Millewa Forest Supply Project

Addendum Review of Environmental Factors

July 2024

Figure 3-1 Revised Pinchgut regulator construction footprint

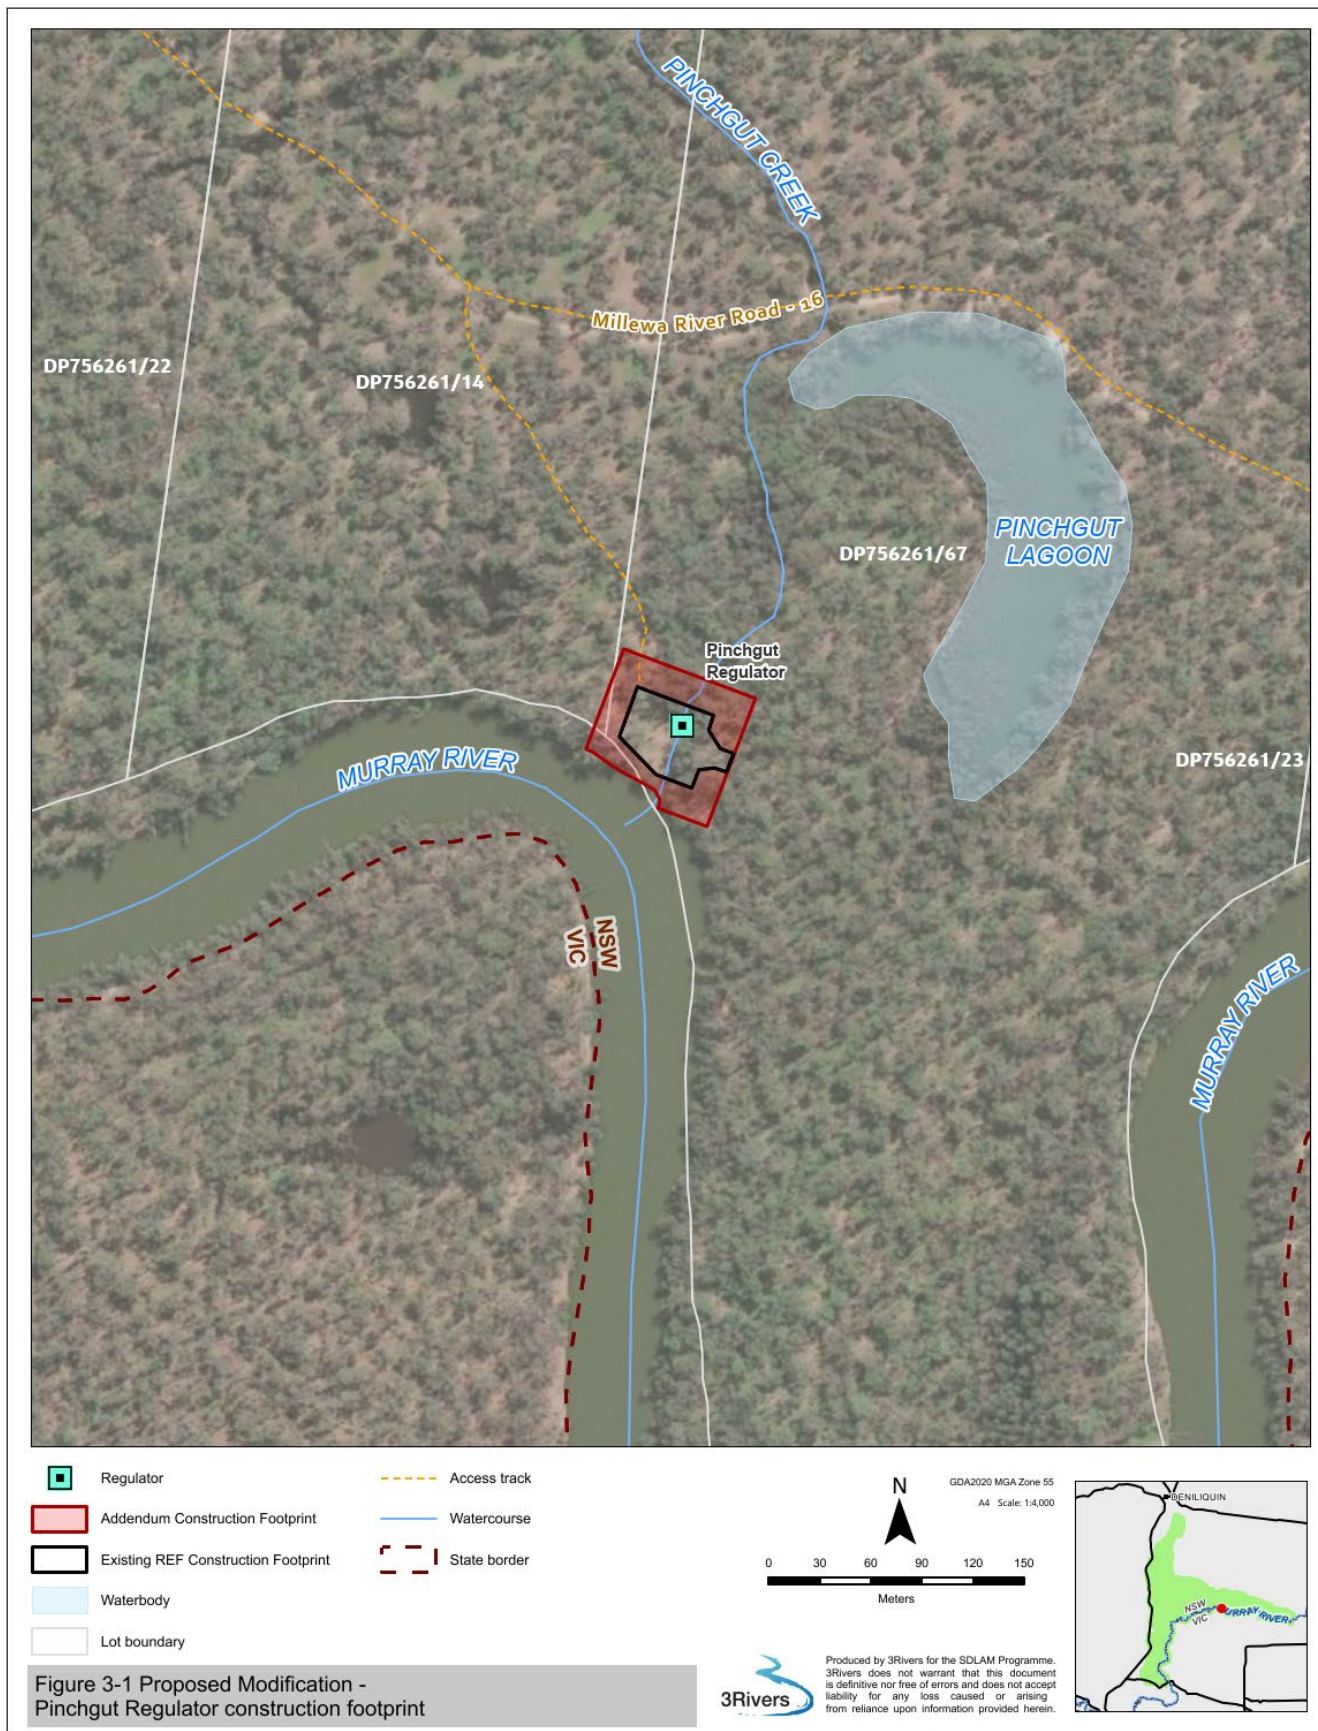
- Extend the construction footprint, in particular the temporary work area approved in the existing REF, to allow for safe and efficient construction of the proposed regulators. The expanded footprint would provide additional area for construction vehicles turning, access along the upstream banks to construct the temporary cofferdam, placement of temporary site office facilities and a buffer for general construction activities.

The revised proposal would expand the construction footprint at each site to provide adequate safe for construction vehicle movements and general construction activities with an associated increase in vegetation clearance and ground disturbance. The revised proposal would expand the construction footprint as follows:

- Additional vegetation clearing and trimming within the addendum construction footprint to provide plant and vehicle access and create space for truck turning, loading and unloading of vehicles, storage of plant and equipment, stockpiling of materials and site office facilities
- If required, additional minor earthworks to enable vehicles and plant to safely operate within the construction footprint.

An overview of the addendum construction footprint at each site is provided in Figure 3-1, Figure 3-2, Figure 3-3 and Figure 3-4.

Figure 3-6 Section view of proposed Nestrans regulator

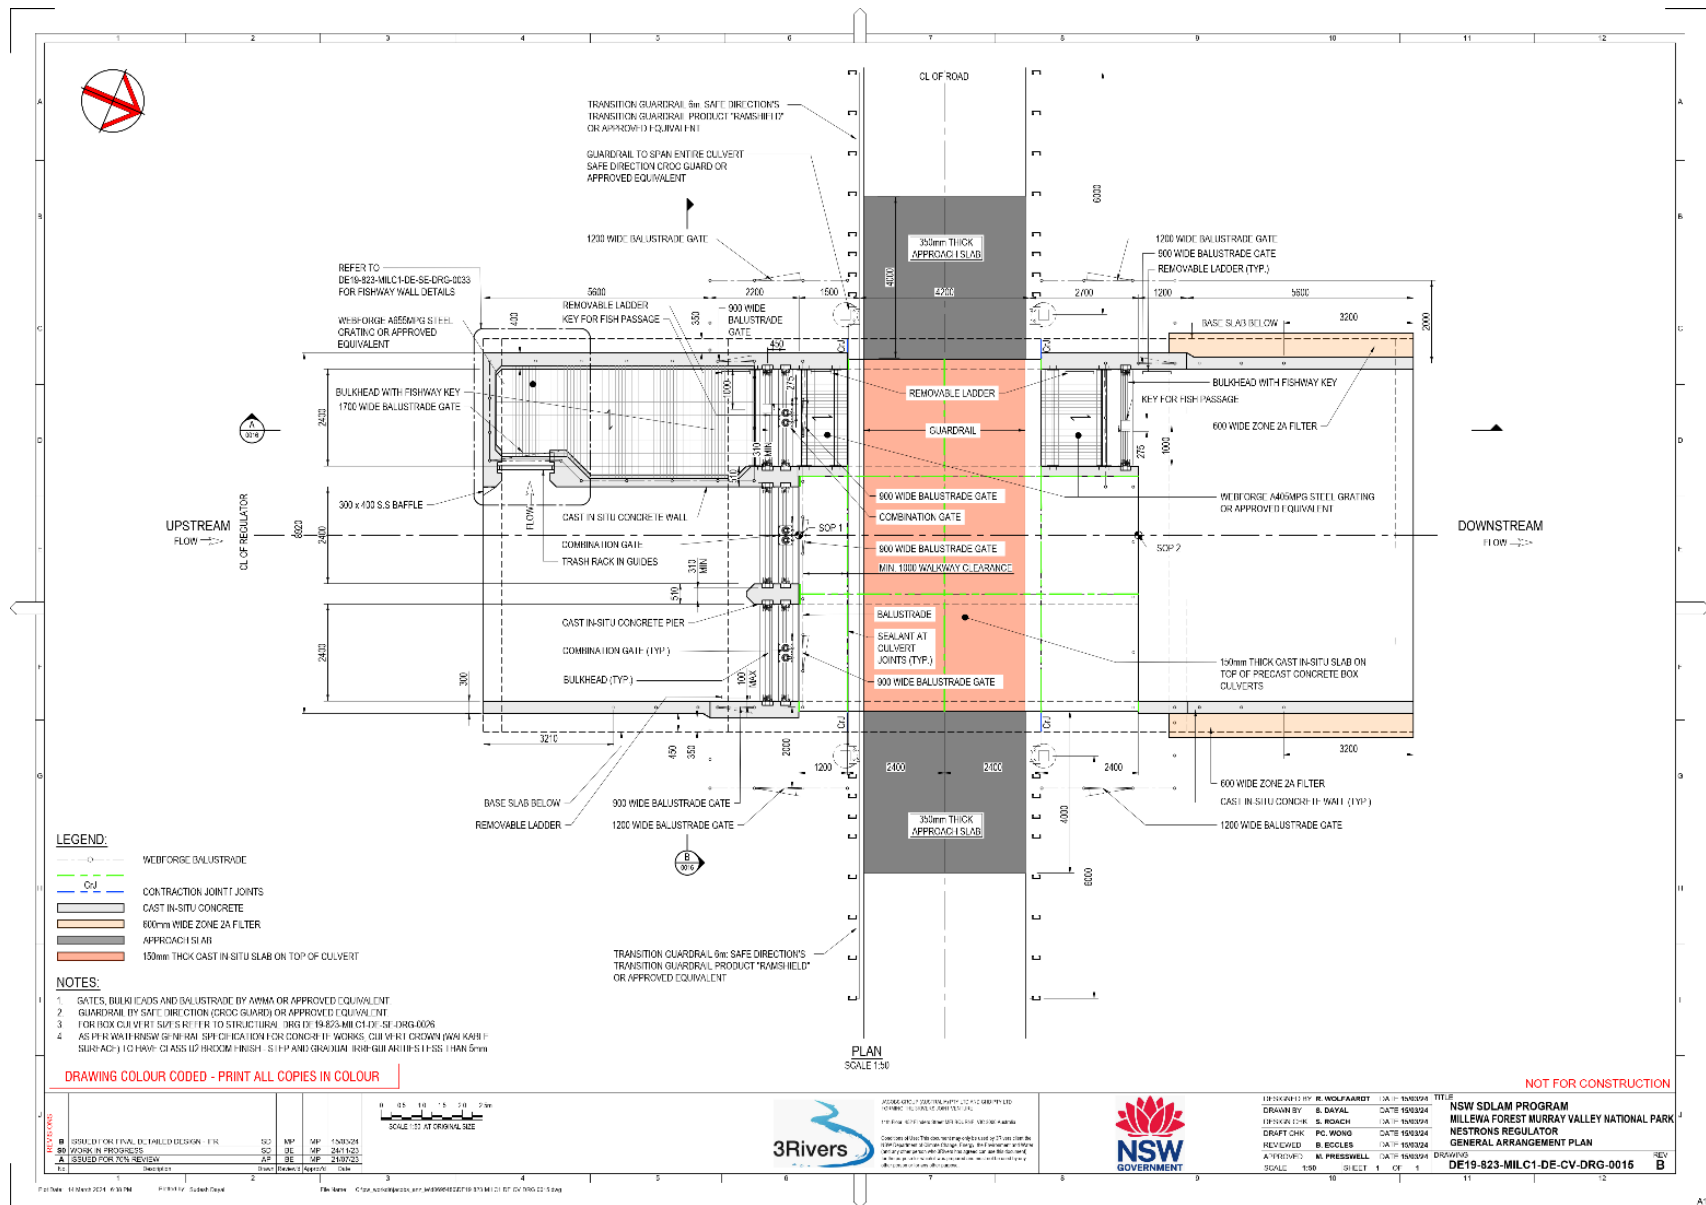
The addition of a third slot to the Nestrons regulator fishway would provide sufficient water depth and lower flow velocity so fish can move safely between the slots under a greater range of flow conditions. In particular, the third slot will improve fish passage for small-bodied fish, who use burst speed to travel through each slot and require increased water depth and lower flow velocities in the pool to rest between slots.

A section view of the Pinchgut regulator design is provided in Figure 3-5. A section view of the Nestrons regulator design is provided in Figure 3-6.

Figure 3-8 Section view of proposed Little Edward River offtake regulator

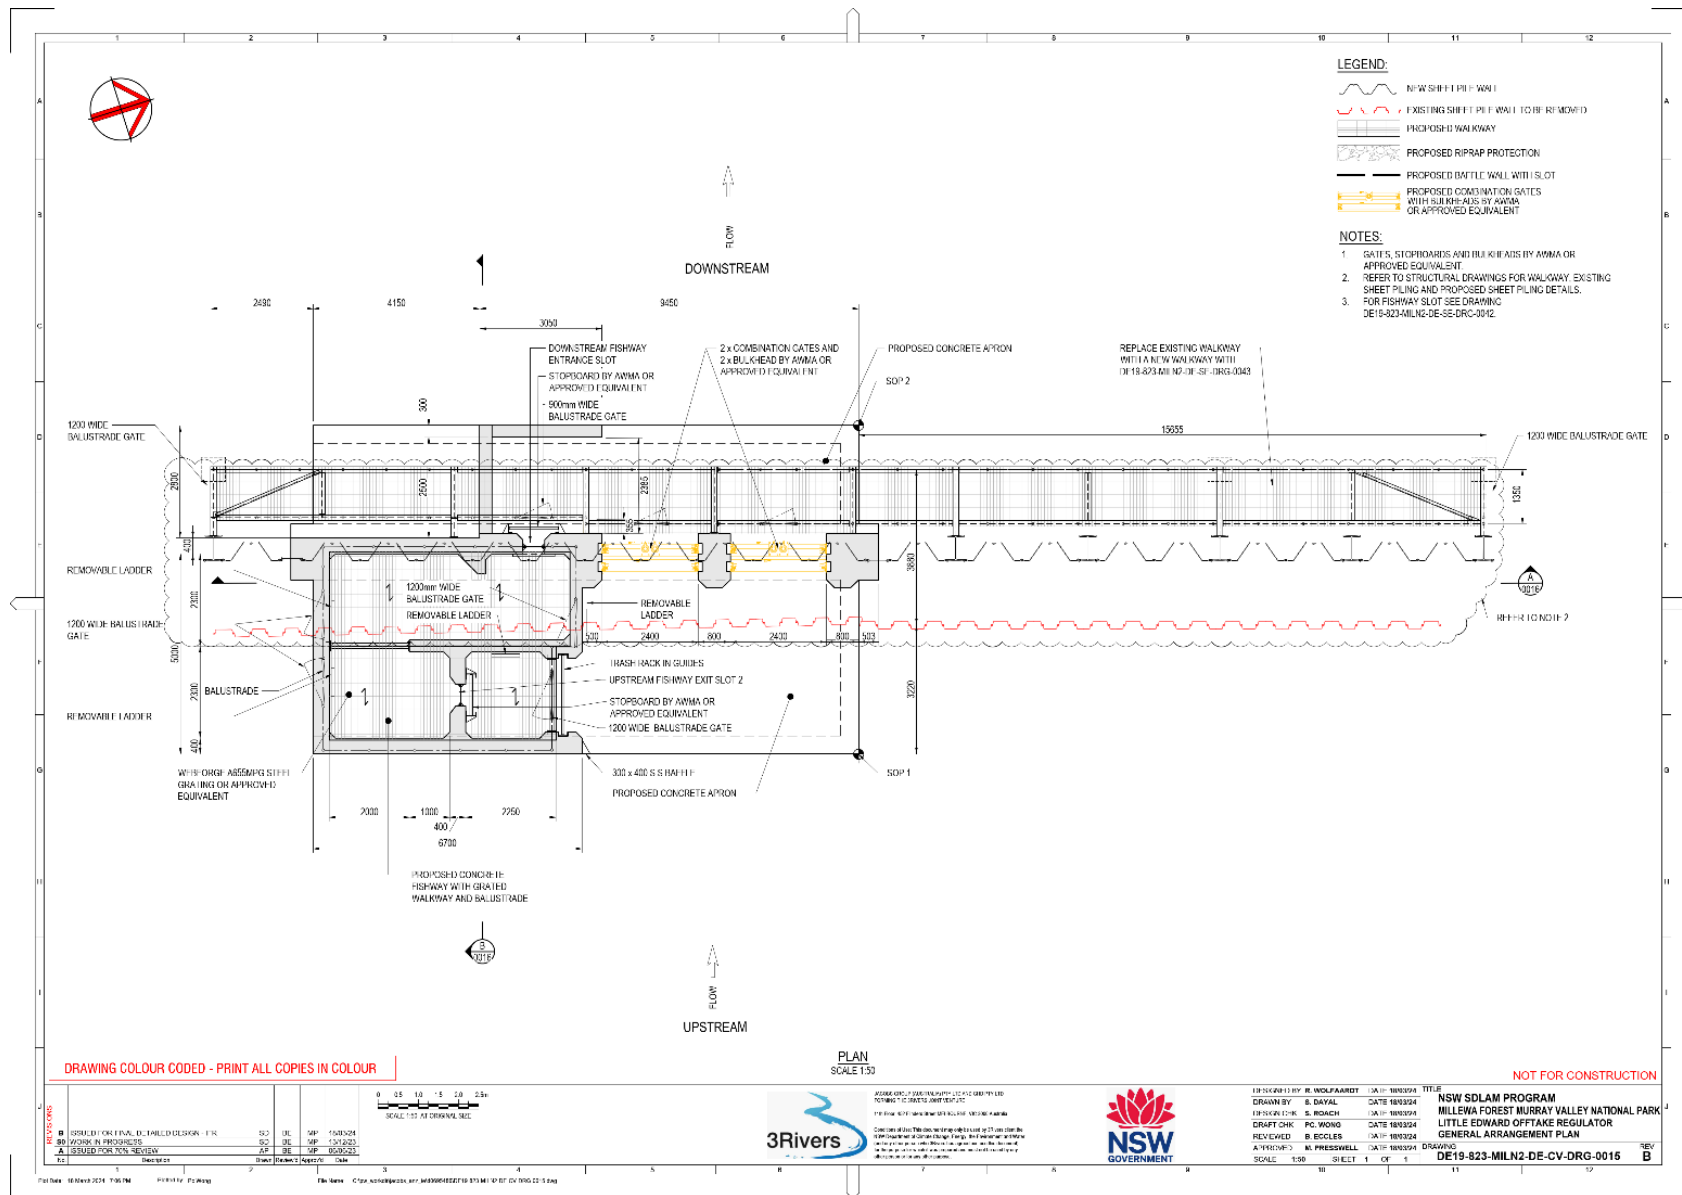
The Little Edwards design has been changed to install a new sheet pile given the potential for seepage at this structure and the uncertainties regarding the condition and depth of the existing sheet pile. The detailed design also replaces the sheet piling that connects to the concrete regulator with a cast in-situ concrete fishway. This change will improve fish passage and increase the load-bearing capacity of this part of the structure. It also has the benefit of a longer asset life and lower maintenance requirements. The invert level for the regulator has been maintained at 92.80 AHD.

A section view of the proposed Little Edward River offtake regulator design is provided in Figure 3-8 over page.
